## Ascent Church

Final Drainage Report

PPR265

All Terrain Engineering Project No: 25023

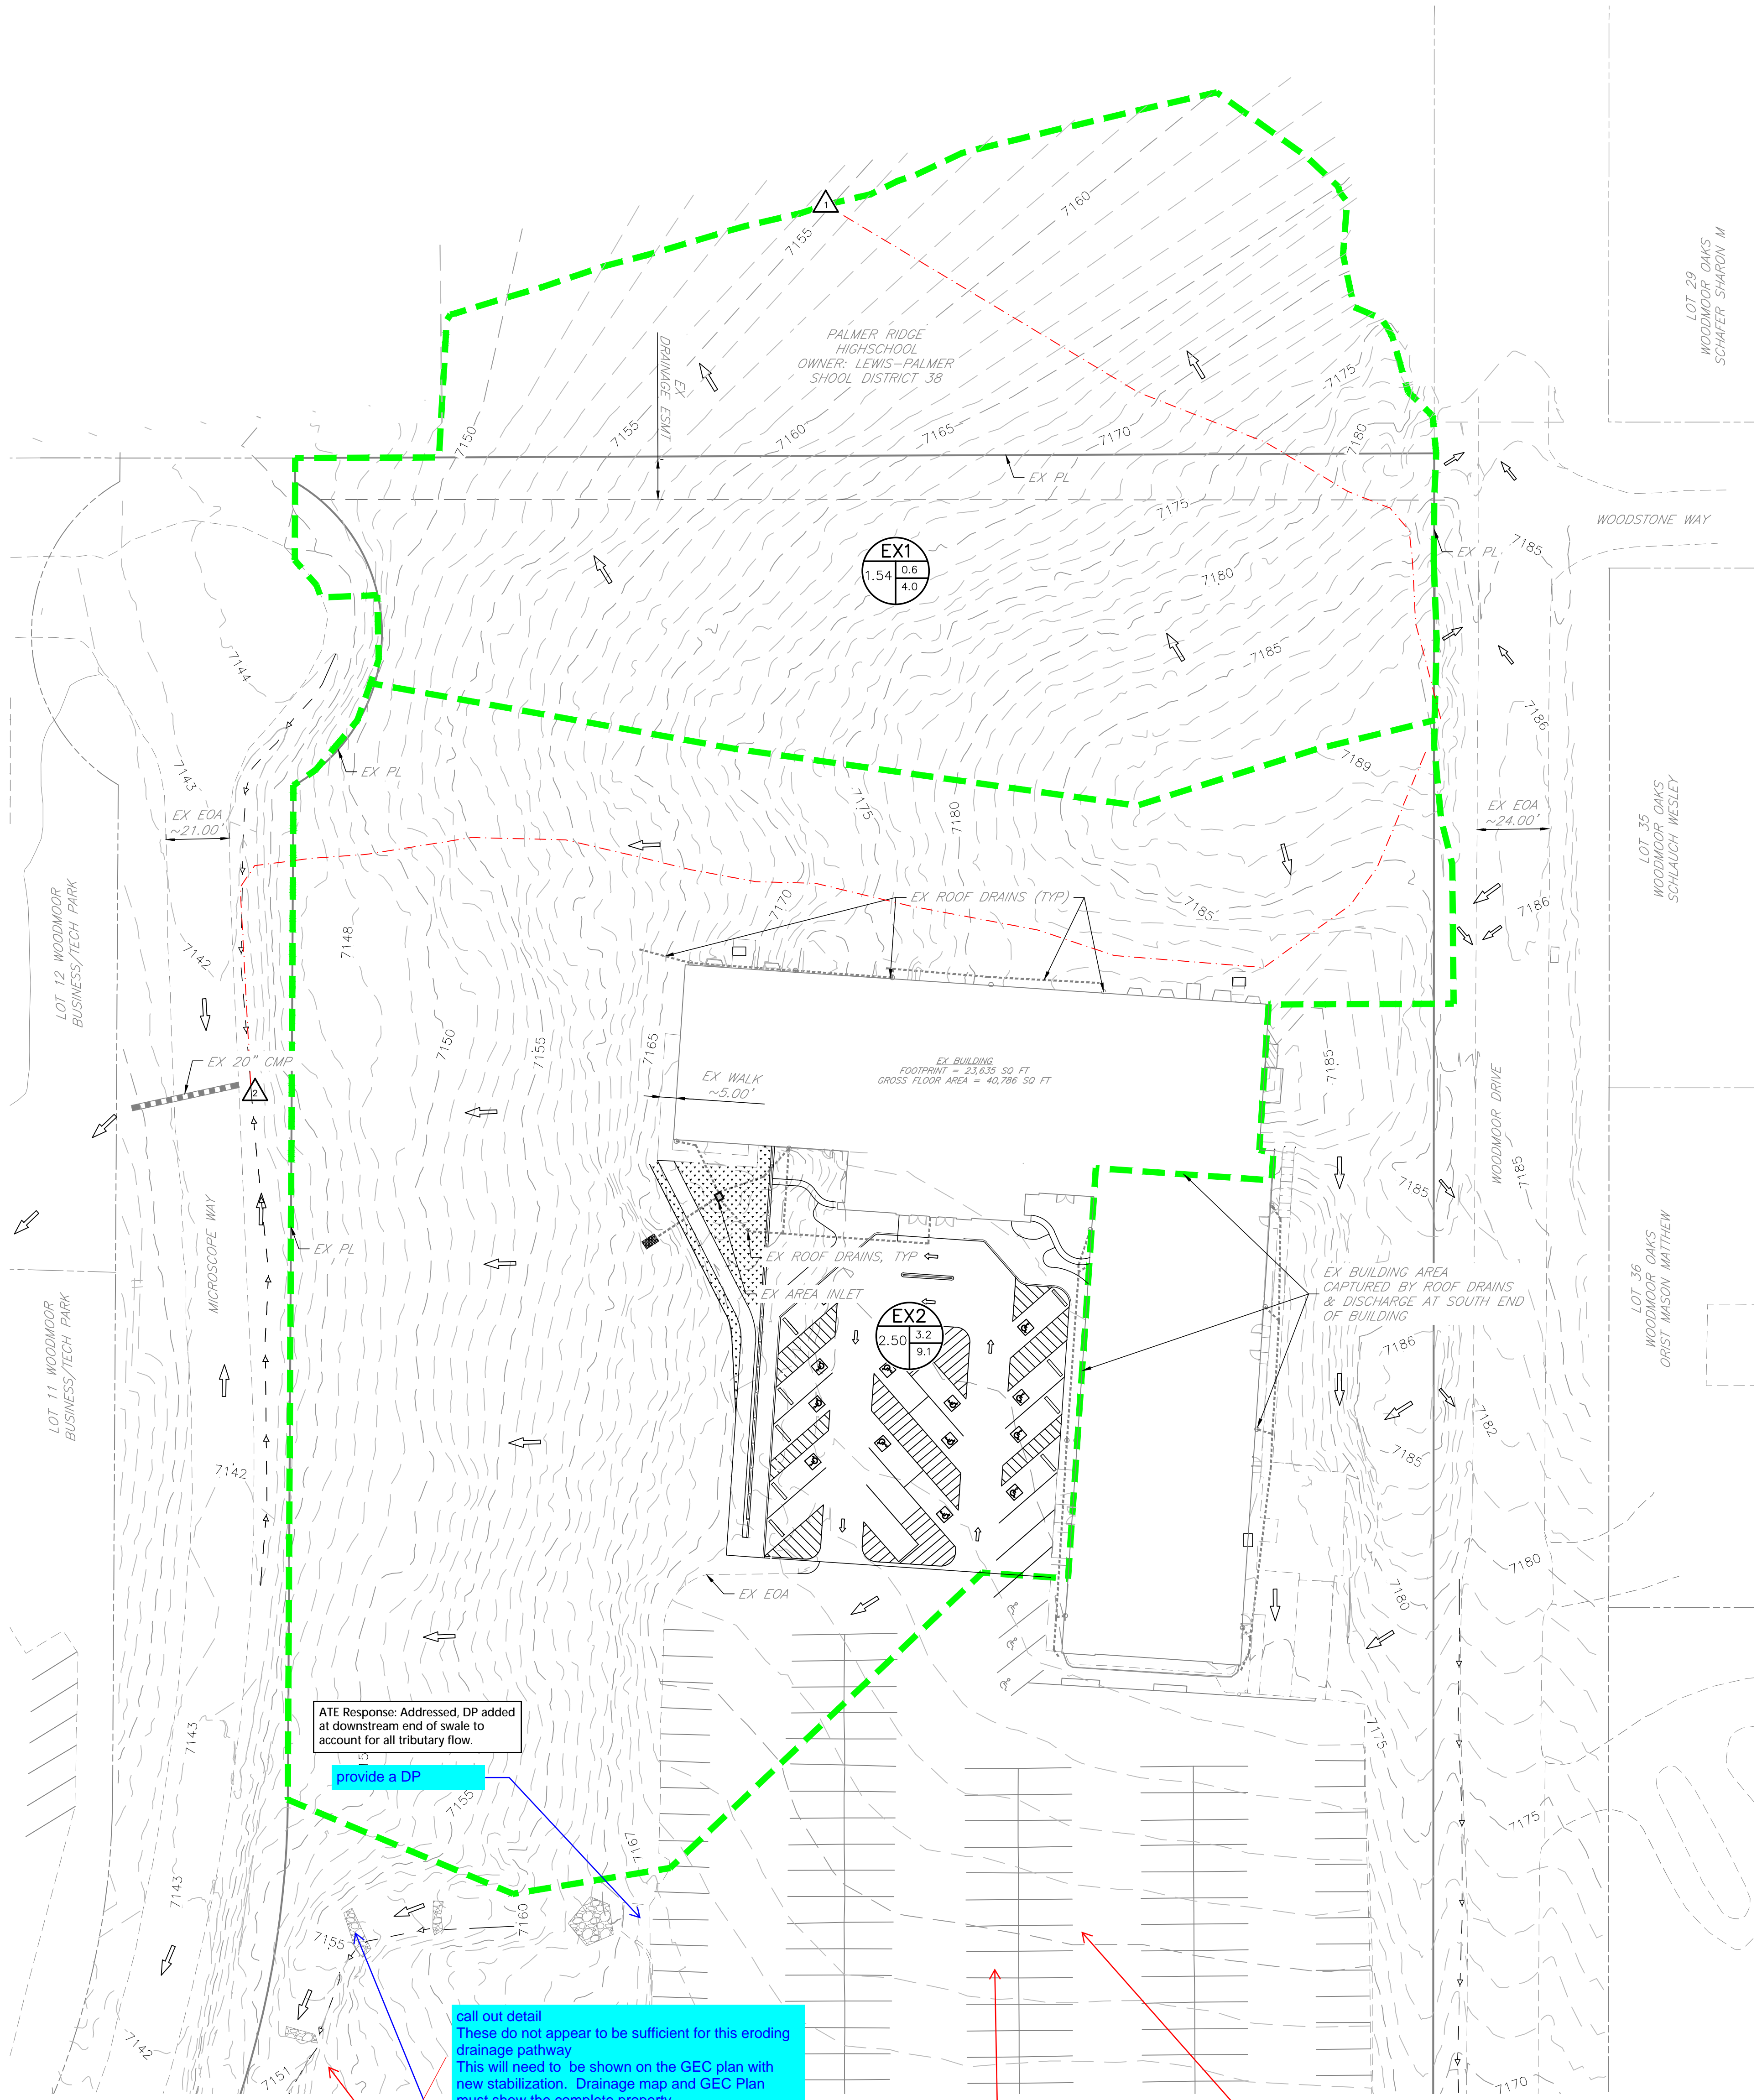
provide a DP

call out detail  
These do not appear to be sufficient for this eroding drainage pathway  
This will need to be shown on the GEC plan with new stabilization. Drainage map and GEC Plan must show the complete property

Basins appear to be missing  
ATE Response: Addressed.

Show the complete property and all basins to include road side ditches and stormwater infrastructure  
ATE Response: Addressed.

ATE Response: Addressed, DP added at downstream end of swale to account for all tributary flow.

ATE Response: Addressed.

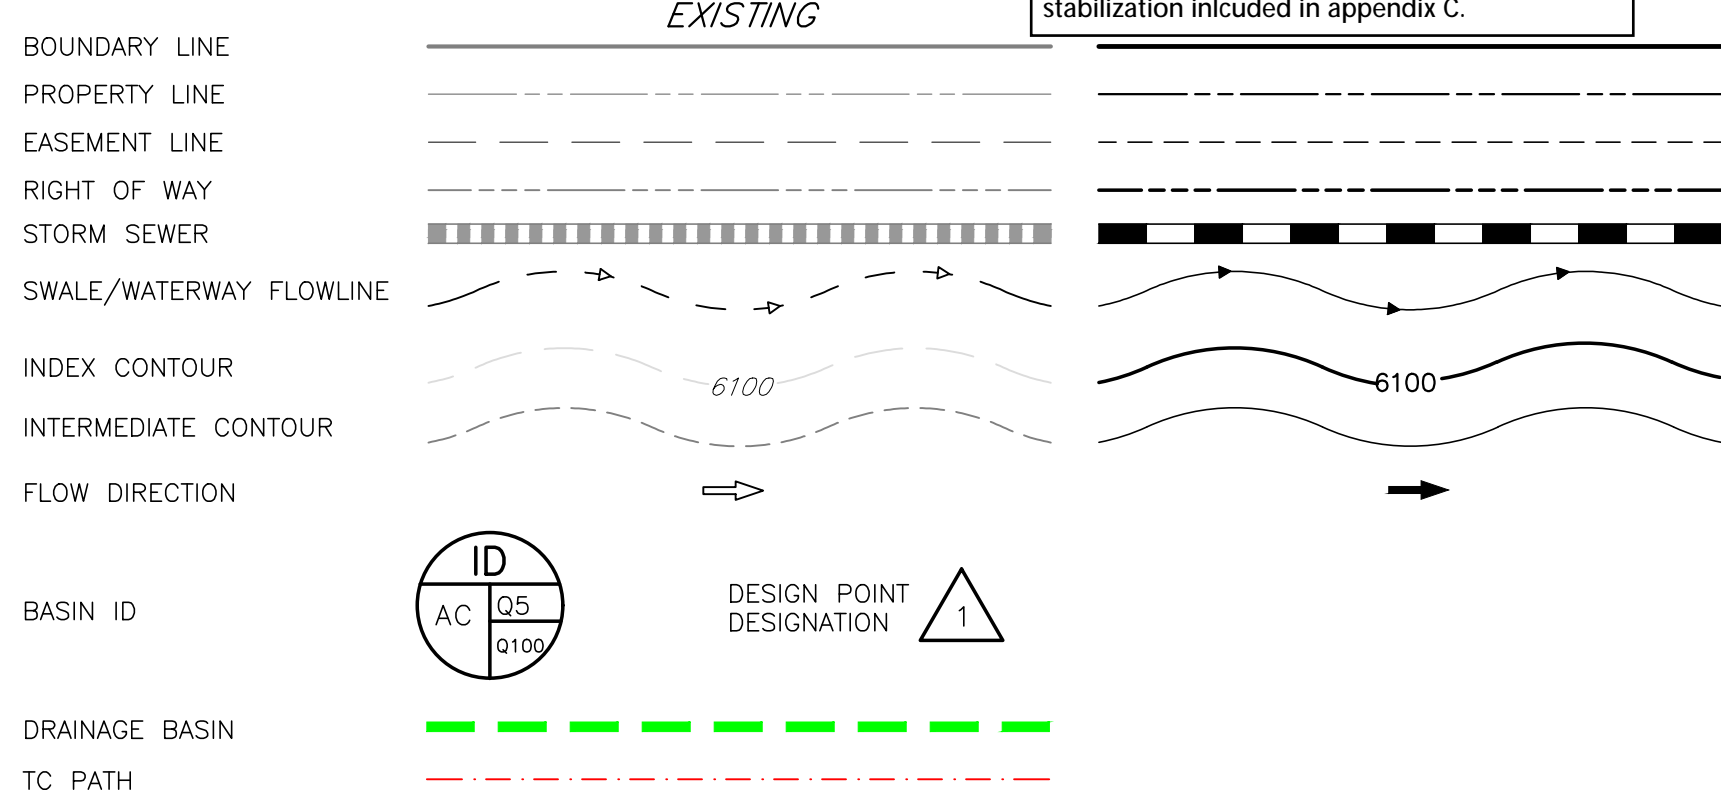
Please consider doing a  
concrete trickle channel  
at the southern end of the  
parking lot where it  
discharges  
All Terrain: addressed.

Assign a name/number to all PCMs and then  
update all submitted text and drawings  
accordingly. All Terrain: addressed.

The added parking area  
is not included in the hydraulic analysis.  
All Terrain: Addressed.  
See revised calcs and  
map. This area has been  
added to basin analysis  
& detailed as an  
exclusion area.

call out size and type  
Show complete property  
boundary to ditch will  
require stabilization and  
repair  
Show all on GEC plan

Show complete property boundary and all basins  
All Terrain: addressed.

All Terrain: Addressed.  
However, DP is placed  
at end of swale so that  
total flow entering  
swale is used for sizing.
